UNIVERSITY OF SOUTH CAROLINA CAPSTONE CAMPUS ROOM UPGRADES

PROJECT NO: 11103

ADDENDUM 02

March 16, 2012

5
1-7
CEILING DETAIL
SCALE: 1 1/2" = 1'-0"

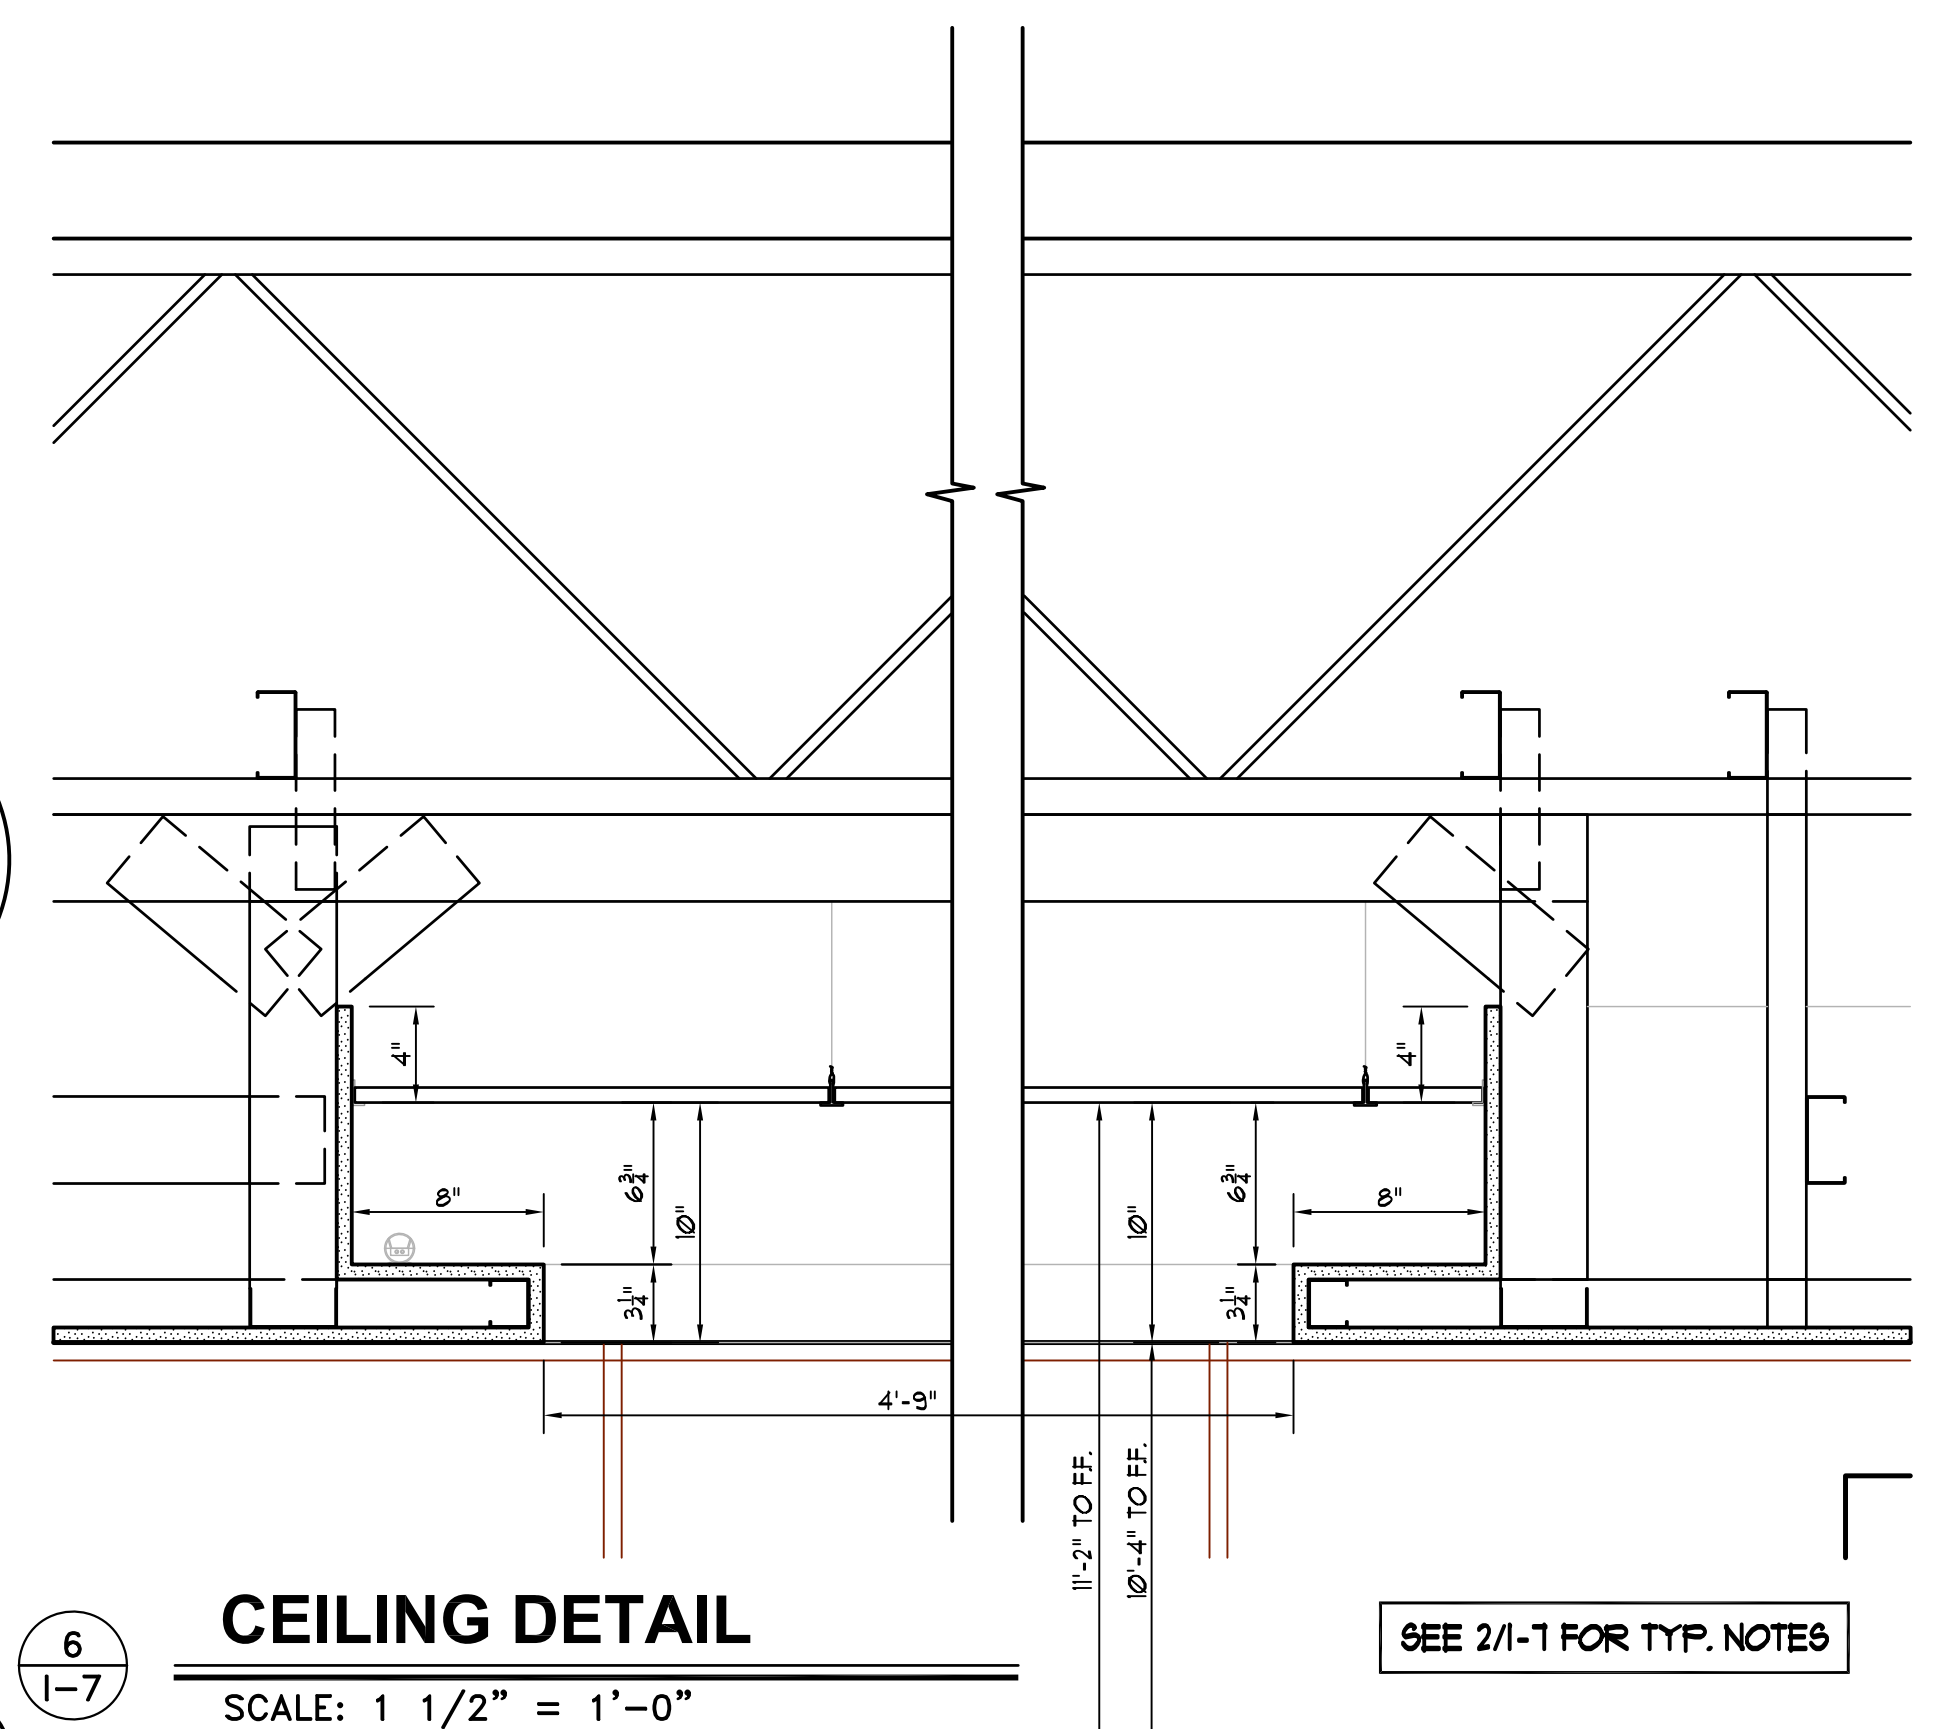
1. **Drawing I-7 CEILING DETAILS:** OMIT Drawing I-7 and **REPLACE** it with NEW DRAWING I-7.
2. **Drawing I-5 DOOR & FINISH SCHEDULES / COLOR SCHEDULE / DOOR & WINDOW TYPES & DETAILS / PANEL DETAILS:** CHANGE Wood Veneer Panel Reveal Details as shown.
